## **Town of Arlington, MA Redevelopment Board**

### **Agenda & Meeting Notice July 22, 2019**

#### **1. Environmental Design Review, 1207-1211 Massachusetts Avenue, Arlington, MA - Docket #3602 Public Hearing**

# SPECIAL PERMIT - SITE PLAN REVIEW

6:00 PM

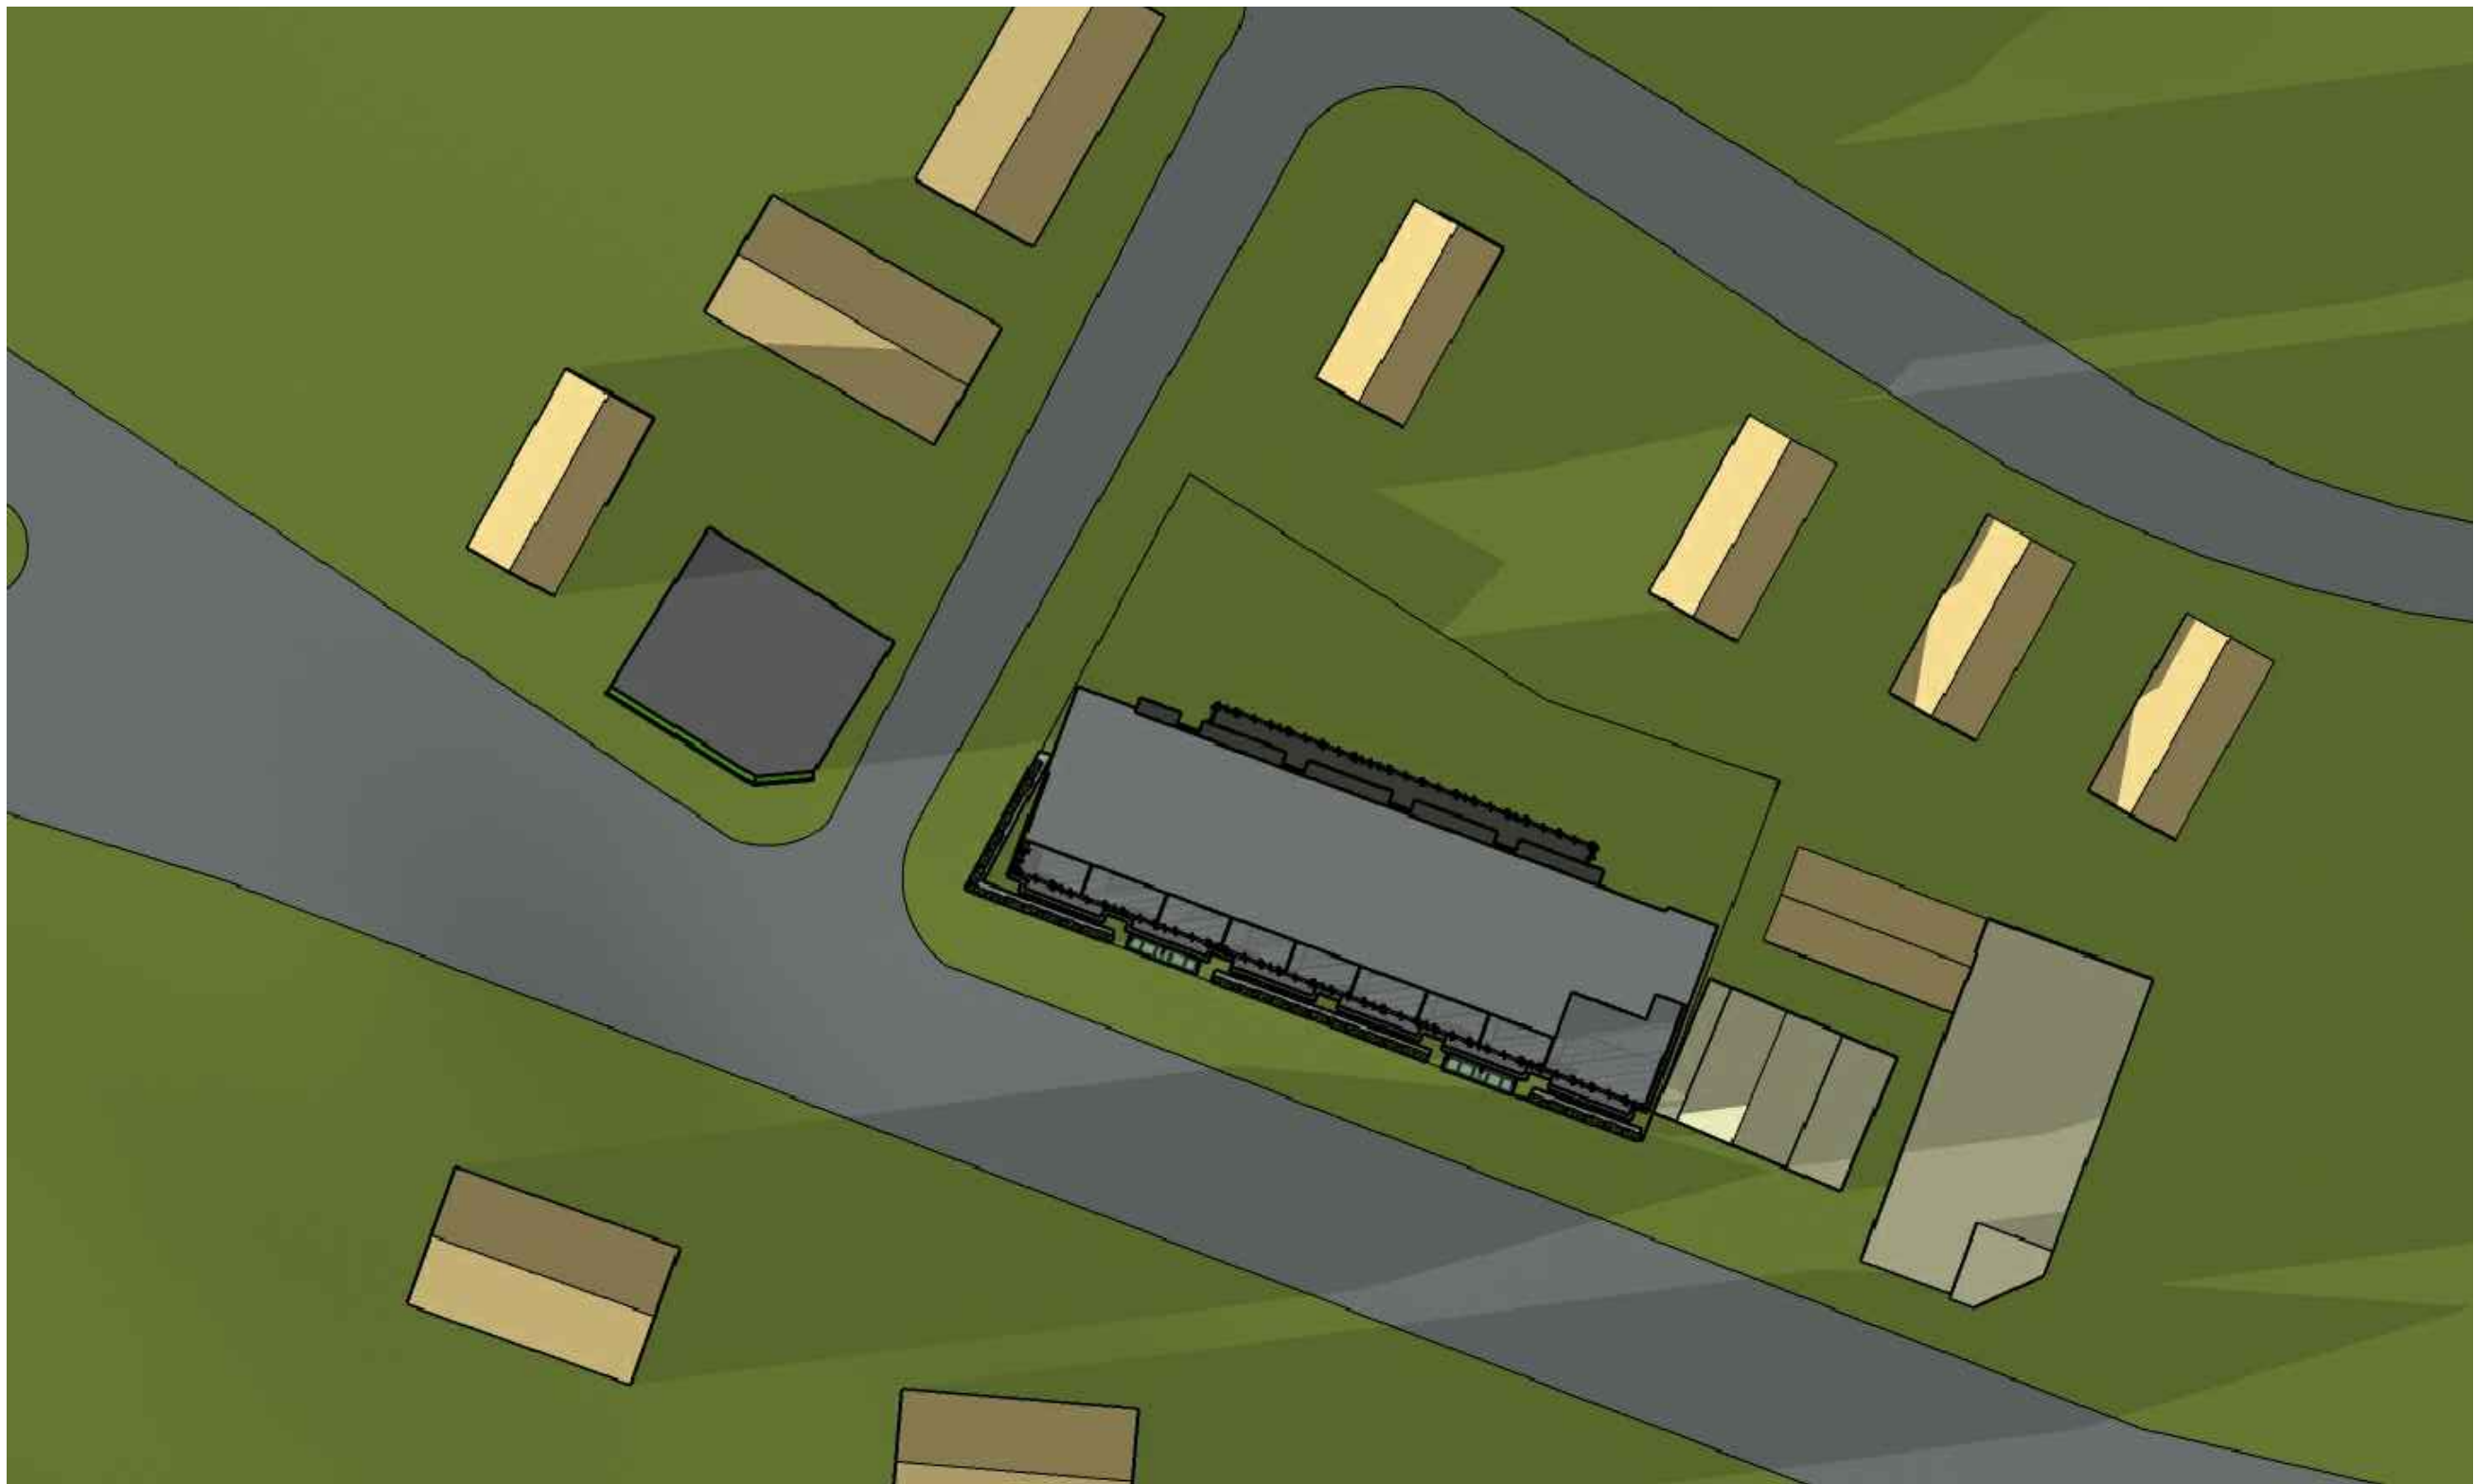
The building does not trigger the height buffer area of Section 5.3.19 because it is proposed at the lower maximum stories and height as identified in the Table of Dimensional and Density Requirements for the Business Districts. However, the application materials also provide a shadow study during each season at the respective Solstice and Equinox.

The proposed changes do not appear to significantly affect the immediate microclimate, however, the height of the new building may create shadows on adjacent residences, and the proximity of Mill Brook should raise questions about additional stormwater inputs and flooding impacts.
